FORD:

2015-2017 Edge

ISSUE

Some 2015-2017 Edge vehicles may exhibit dirt and/or dust accumulation at the bottom of the front and/or rear door openings. This may be due to extended driving on non-paved roads.

Figure 1 - Article 17-0056

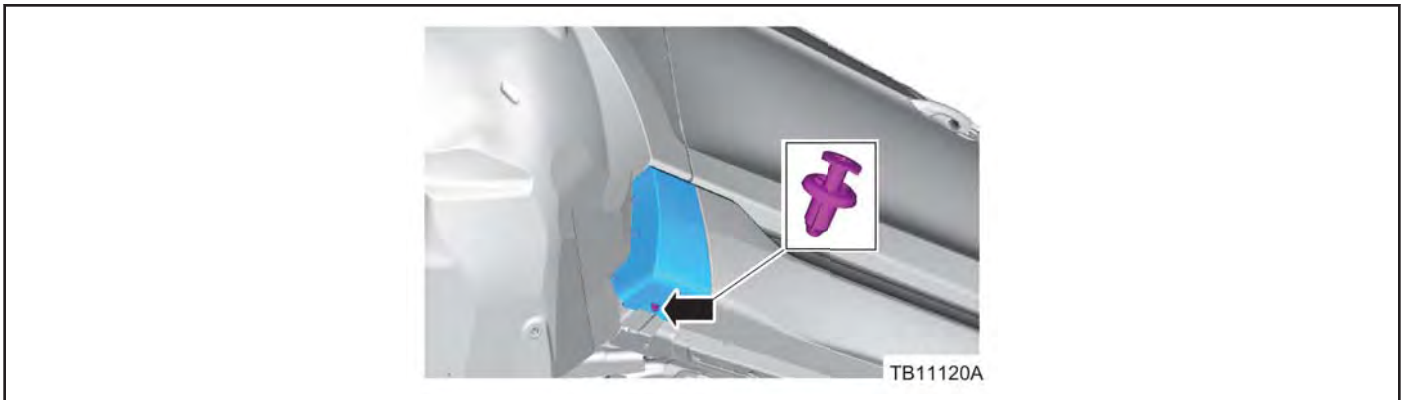
1. Raise the vehicle. Refer to Workshop Manual (WSM), Section 100-02.
2. Remove and discard the attachment lower retainers from the left and right side rocker panel moulding end caps located behind the front tires. (Figure 1)

Figure 2 - Article 17-0056

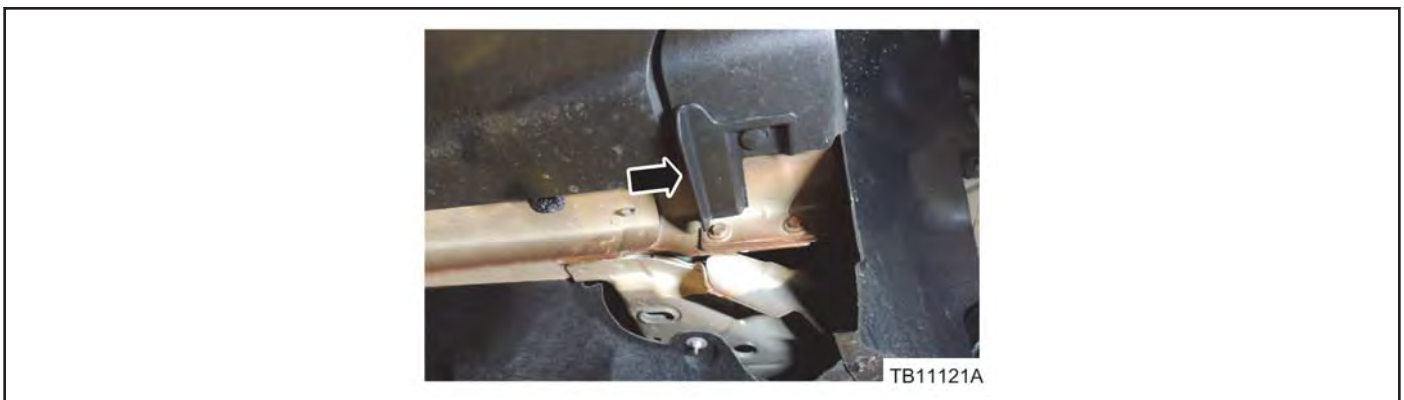
3. Install the mini mud flaps under the rocker panel moulding end caps using a new attachment lower retainer. (Figure 2)
